City of Ukiah

ZONING ADMINISTRATOR

- A.** Request for Review and Recommendation on a Minor Site Development Permit to expand the existing grave site area to include: live landscaping and an open Memorial Pavilion at 940 Low Gap Road; (Russian River Cemetery District).
APN 001-020-63 File No.: Munis 2130-SDP-ZA.

SUBJECT: Request for approval of a Minor Site Development Permit for a six column open Niche Memorial Pavilion and new landscaping at 940 Low Gap Road, APN 002-160-63 File No.: 2130-SDP-ZA.

SHEET TITLE:
PROJECT RENDERING

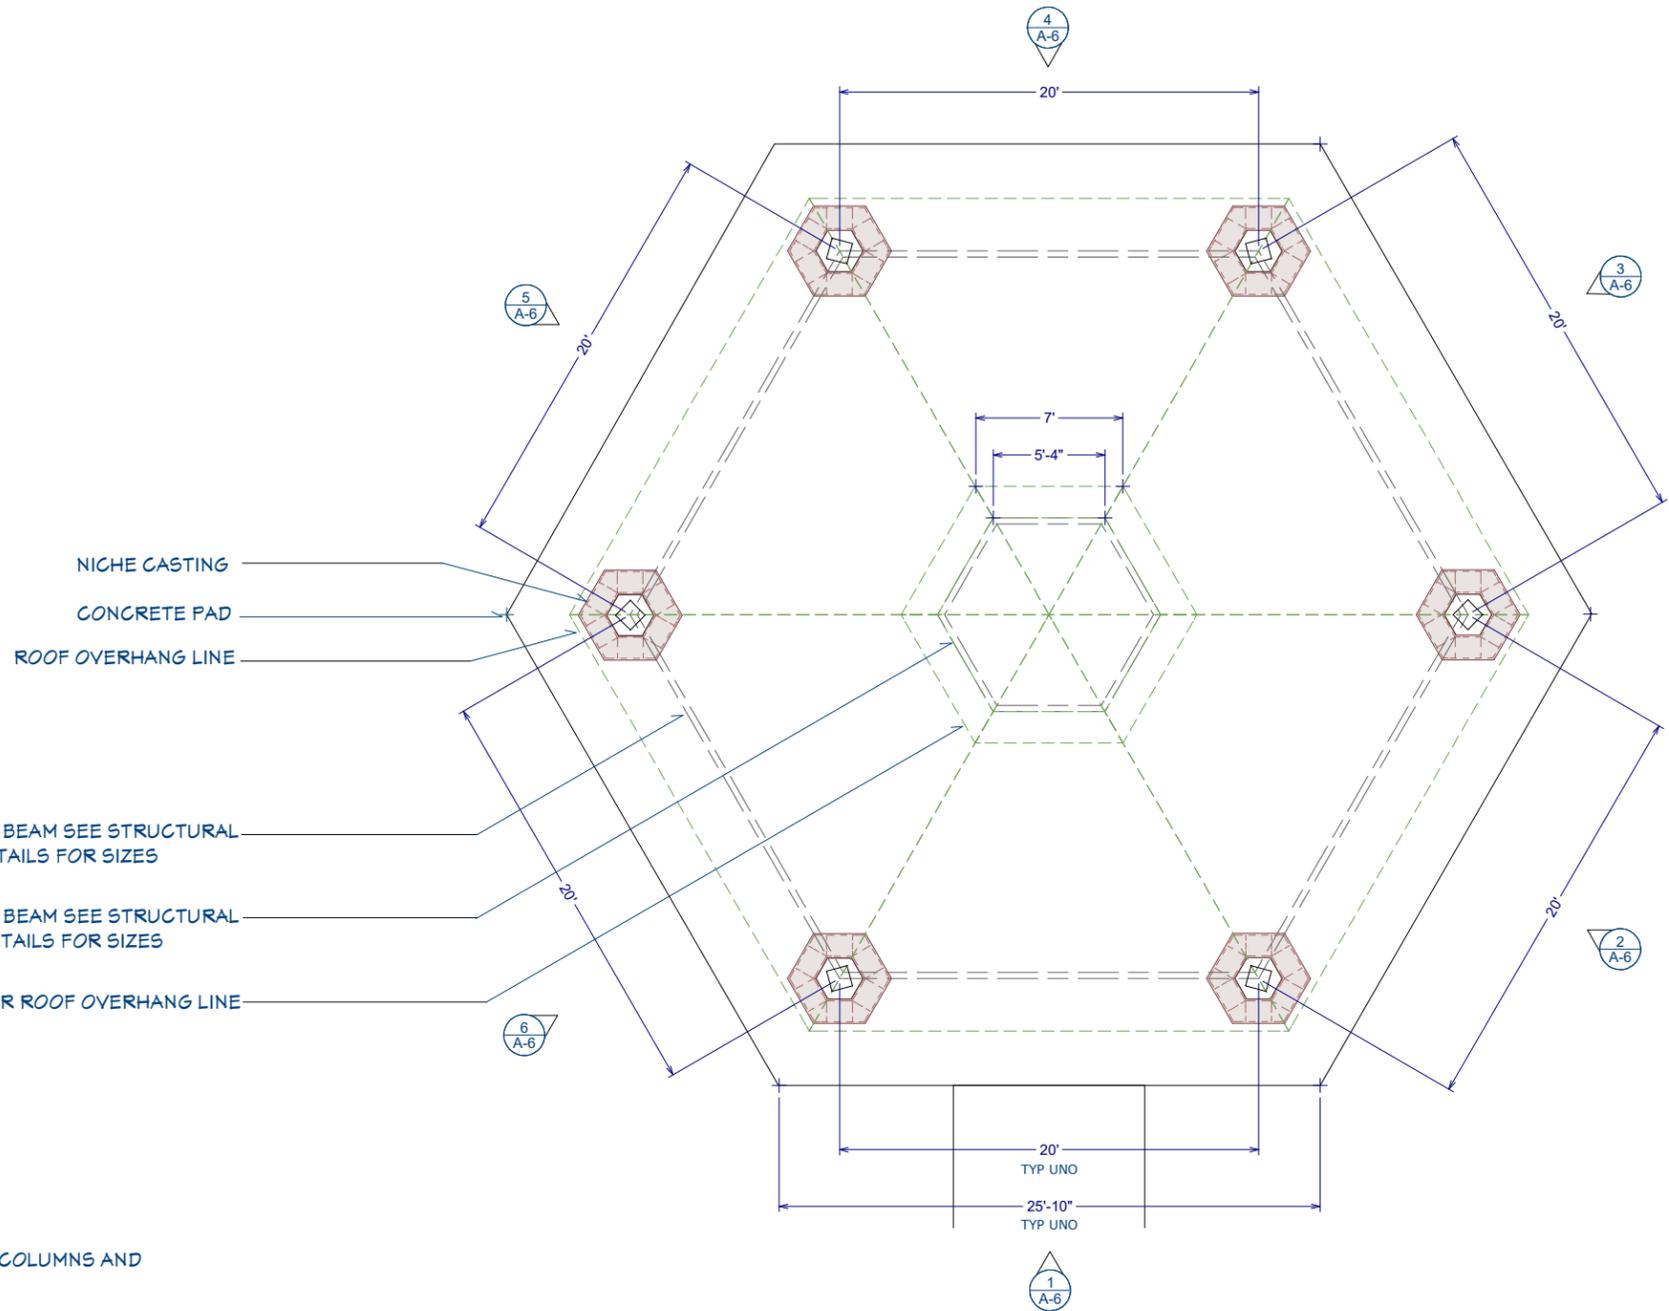
- 7 • Referred to the building plans and inquired whether the 'golden garnet granite' colored
8 boxes contain the ashes of people.
9 • Requested clarification the opening part of the boxes face outward.
10 • Would like to see less color contrast for the granite shutters that are light in color (golden
11 garnet granite) and the corresponding castings that are of a dark color (New Dakota aka
12 Dakota Mahogany Granite).
13

- 21 • Referred to the project rendering, Sheet A-1 and floor plan of the building plans, sheet A-
22 3 and confirmed the boxes are granite shutters to be 3/4" Golden Garnet Granite and
23 explained how these boxes will be integrated into casings trim to be 3/4" New Dakota
24 Granite in the six columns. The columbarium granite shutters are to be installed with
25 aeon hardware system. Confirmed the boxes would face outward and explained how this
26 works. The boxes are removable when it is time for interment and remains placed inside
27 and secured into the aeon hardware system.
28 • Referred to the design of the pavilion and talked more about the granite shutters, niche
29 castings, and hardware structure and/or all other structural components as to how the
30 pavilion is designed to work.
31 • The pavilion has a roof that overlaps and referred to building plans, Sheet A-5 and A-7.
32 • The pavilion will feature no lighting or signs.

- replace reposed white window frames with a darker color to vinyl to have less of a contrast with the color of the building; and
 - replace the proposed color for the granite columns with a color scheme that does not create a definitive striped appearance having less contrast.

SHEET TITLE:
ELEVATIONS

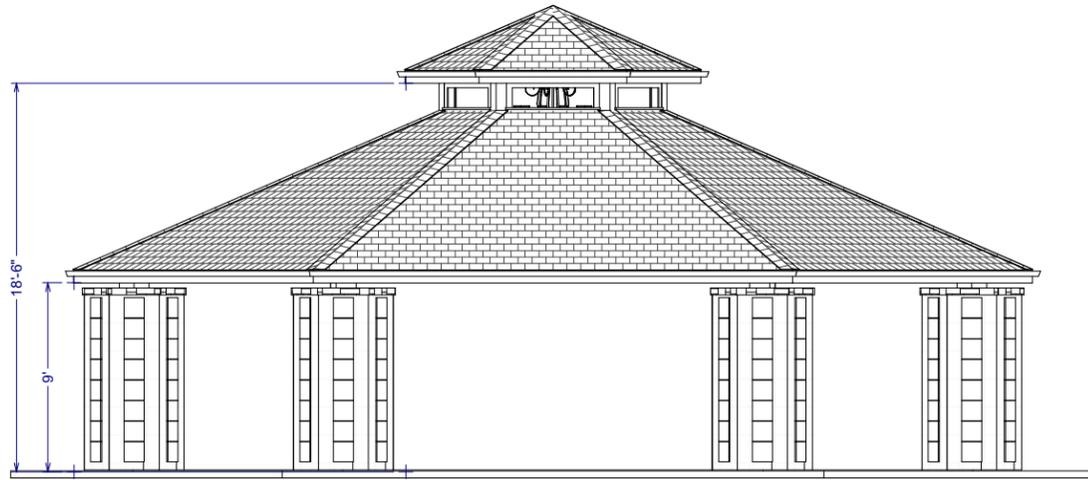
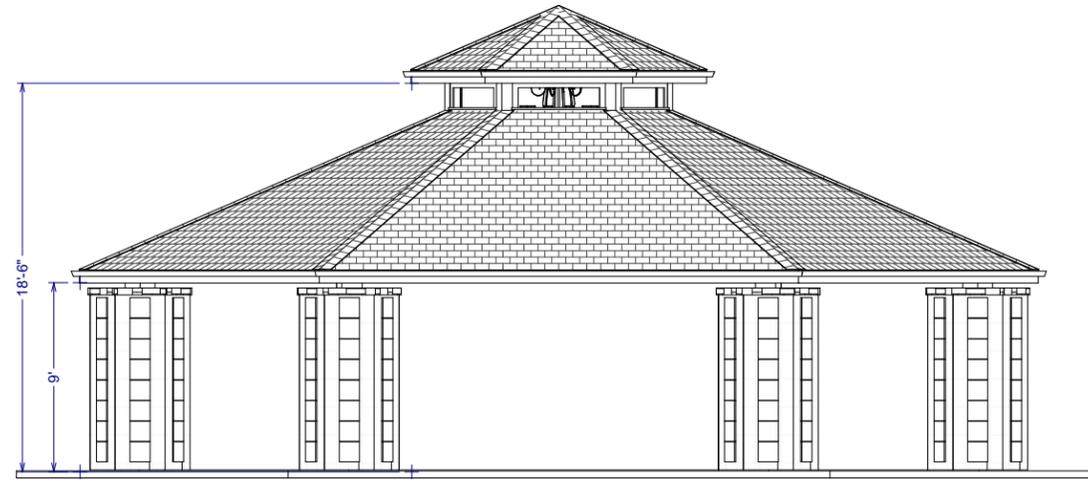
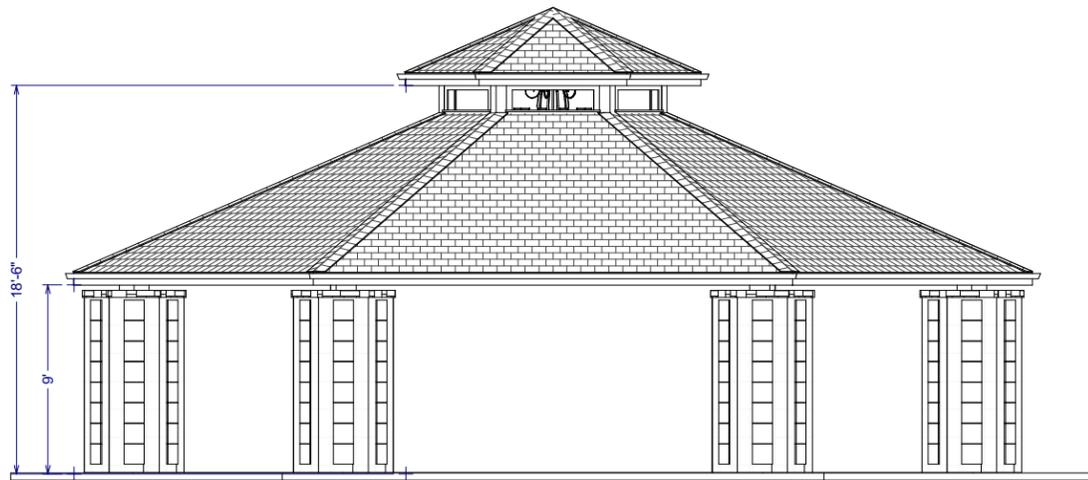
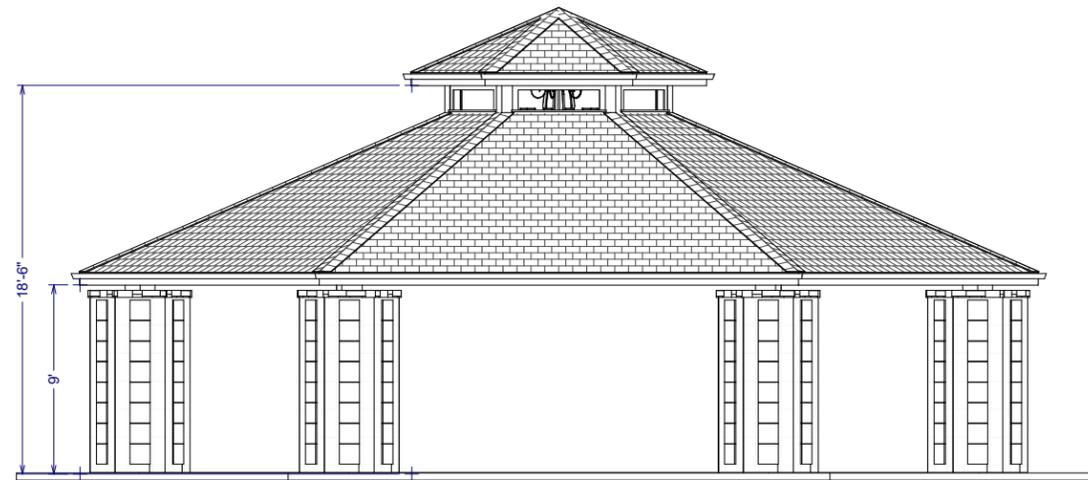
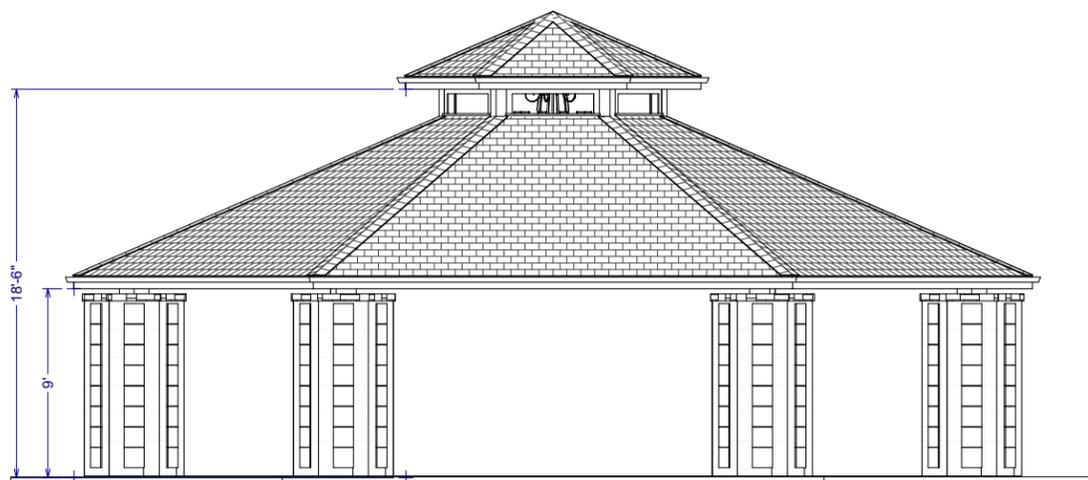
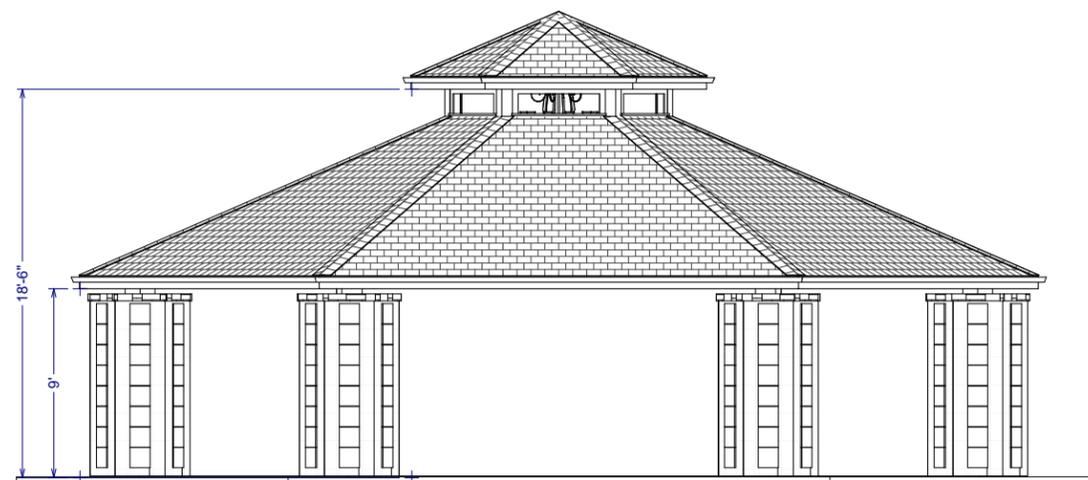
- 5 1. replace reposed white window frames with a darker color to vinyl to have less of a
6 contrast with the color of the building; and
- 7 2. replace the proposed color for the granite columns with a color scheme that does not
8 create a definitive striped appearance having less contrast.

- 33 • The Dakota Mahogany granite relative to the shutter comes in a 'flame' finish which is
34 fairly rough. Could do a 'flamed and polish' finish interchangeably and this would be a
35 subtle transition or use a polished Dakota Mahogany and flamed granite for the shutters.
36 This would provide for a sophisticated appearance. This is only a suggestion. Is of the
37 opinion if the colors were less contrasting the columns would not be so definitively
38 striking in appearance and would be more subtle.
